To: Keas, Ashley[Ashley.Keas@dnr.mo.gov]
Cc: Wilbur, Emily[emily.wilbur@dnr.mo.gov]; Vit, Wendy[wendy.vit@dnr.mo.gov]; Avey, Lance[Avey.Lance@epa.gov]; Algae-Eakin, Amy[Algae-Eakin.Amy@epa.gov]; Gonzalez, Larry[gonzalez.larry@epa.gov]; Jay, Michael[Jay.Michael@epa.gov]
From: Hawkins, Andy
Sent: Tue 8/11/2015 2:07:34 PM
Subject: RE: Interactive Source Question Follow Up

Subject: Interactive Source Question Follow Up

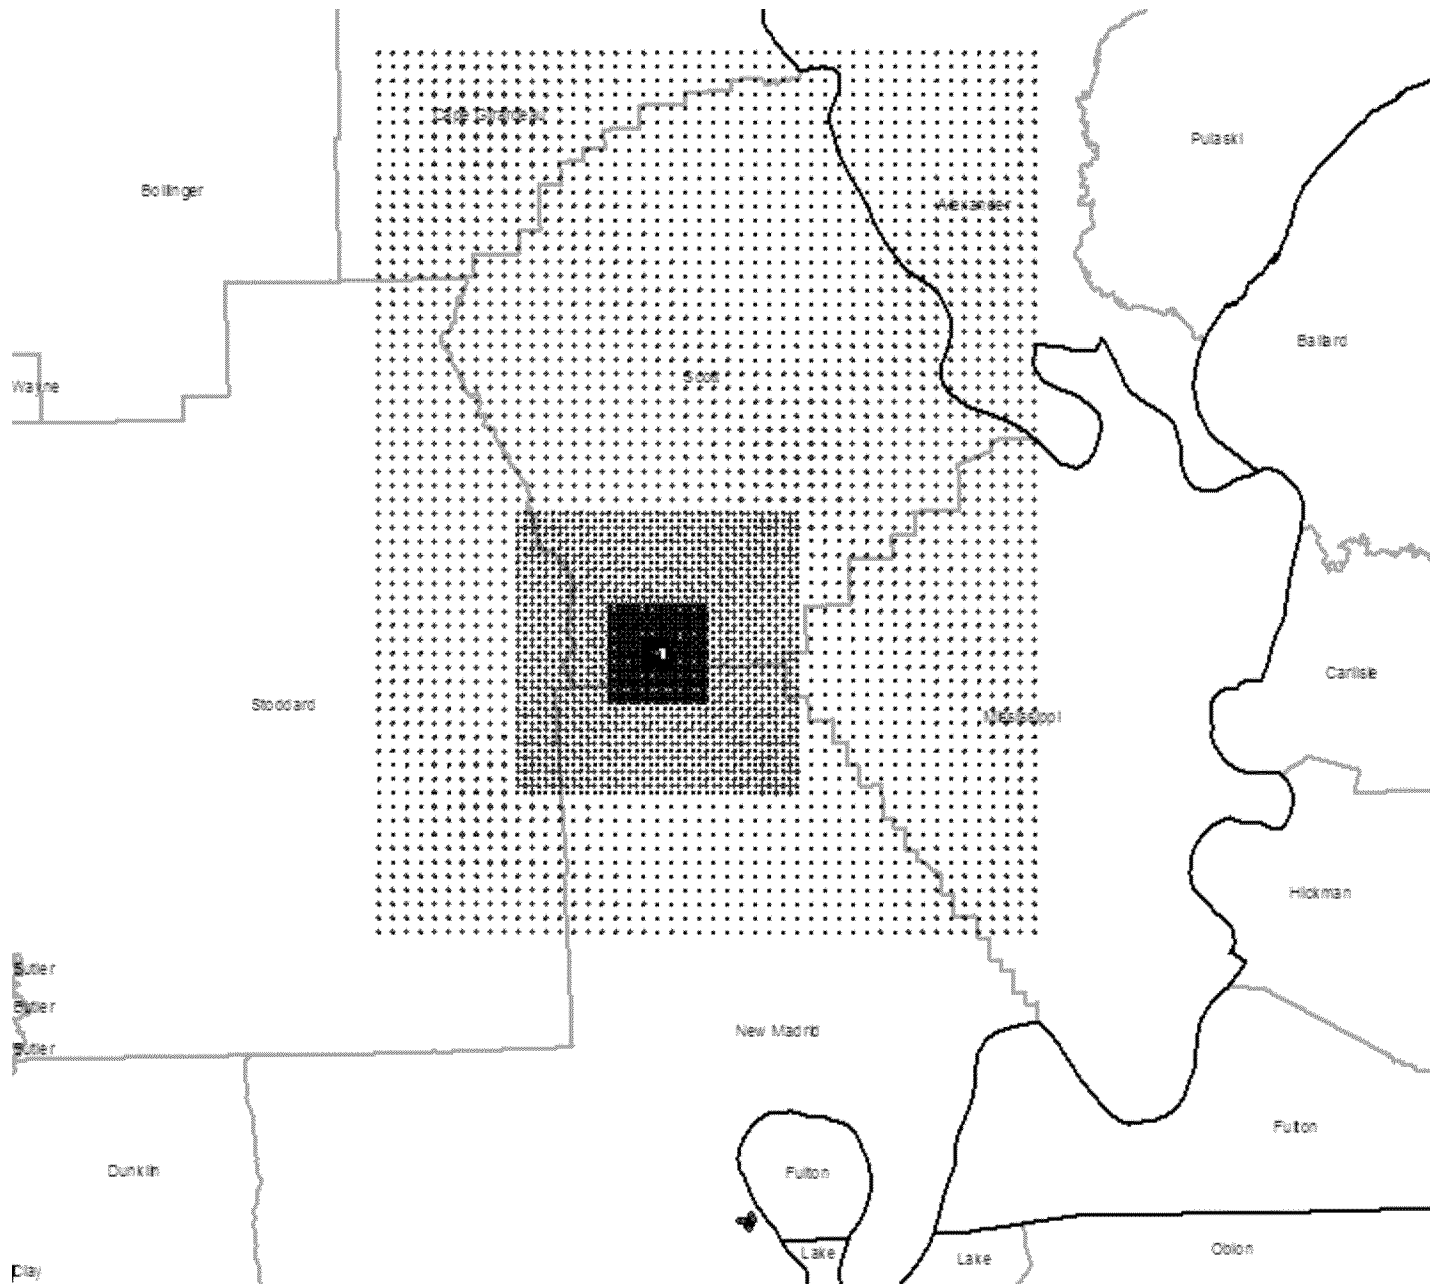
Here are the sources in arcmap for the input file I have, so receptors look fine, but the interactive sources are all bunched to the south (all new madrid I guess). So this means that Buzzi Unicem is not modeled explicitly? It's very close to the proposed attainment area to the north. In the SIP document it says Buzzi is modeled but it does not show up when I map it in the location I expect it at anyway. So please check Buzzi... could be my input file or maybe my import does not work correctly. So the new madrid locations may all be correct, maybe Buzzi is just not in the input?

You are correct. We inadvertently sent you an outdated input file since we had multiple people doing the last minute runs. I will have someone FTP the correct files to you tomorrow.

Sorry about that. Thanks for bringing it to our attention. We are correcting the modeling file Appendix too.

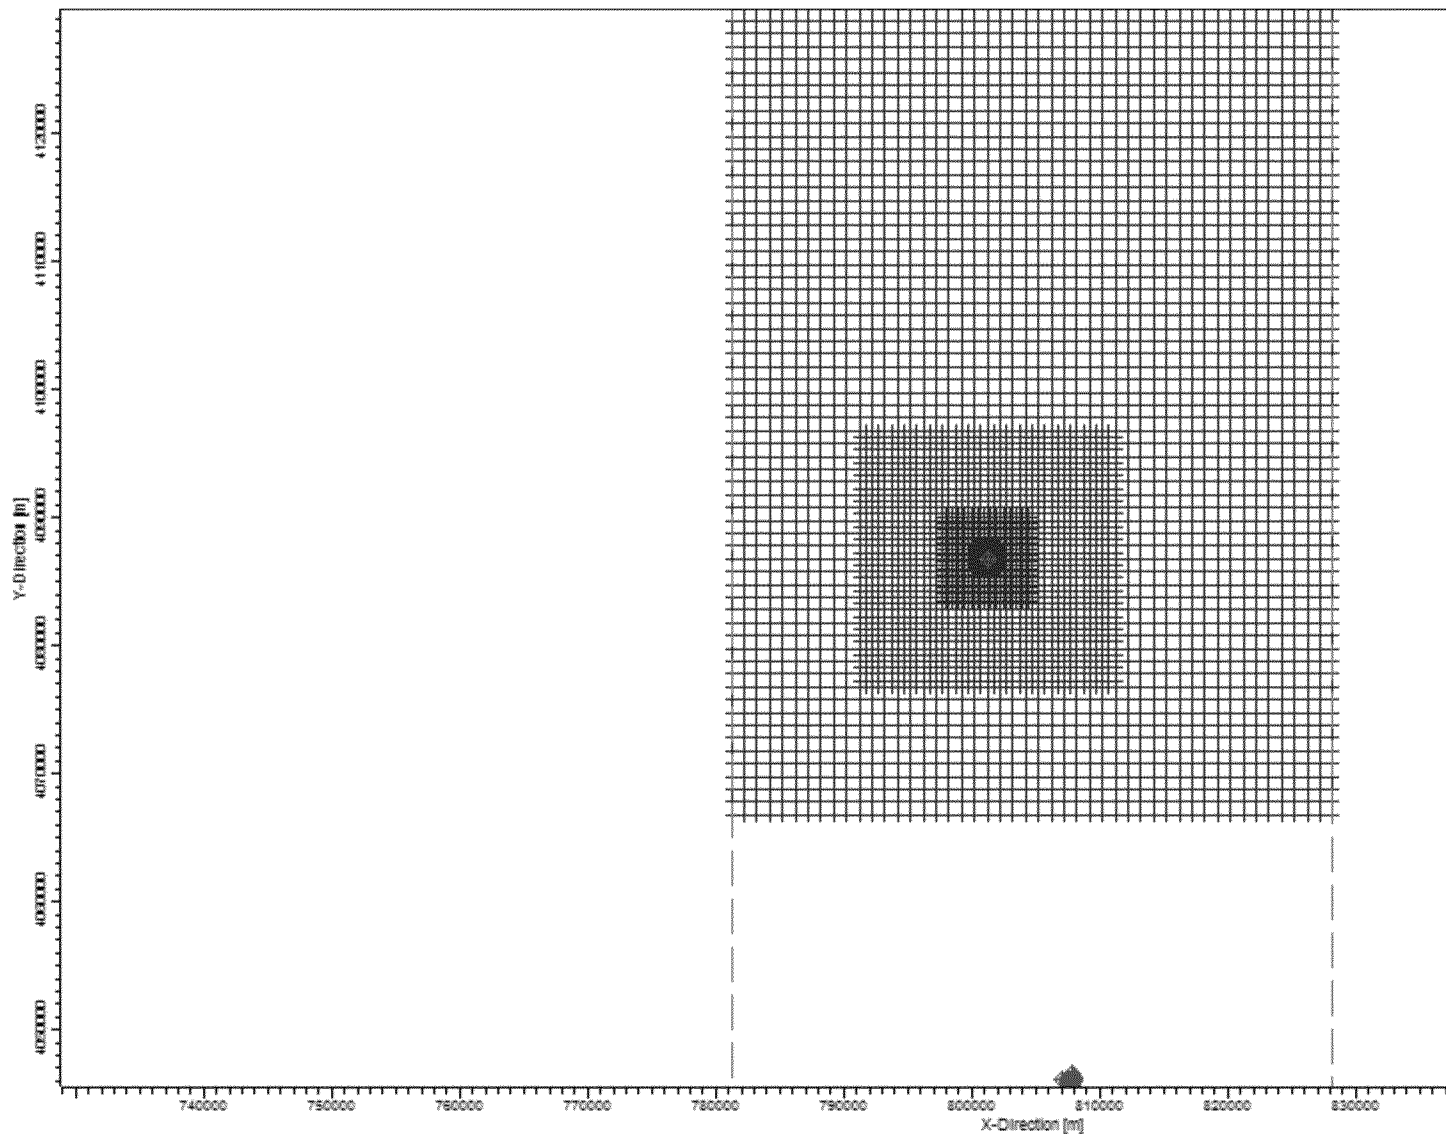
Can you please verify the Sikeston interactive source locations in the AERMOD input file you sent... the locations of the interactive sources look questionable when I import them using the supplied input file for this CD source.
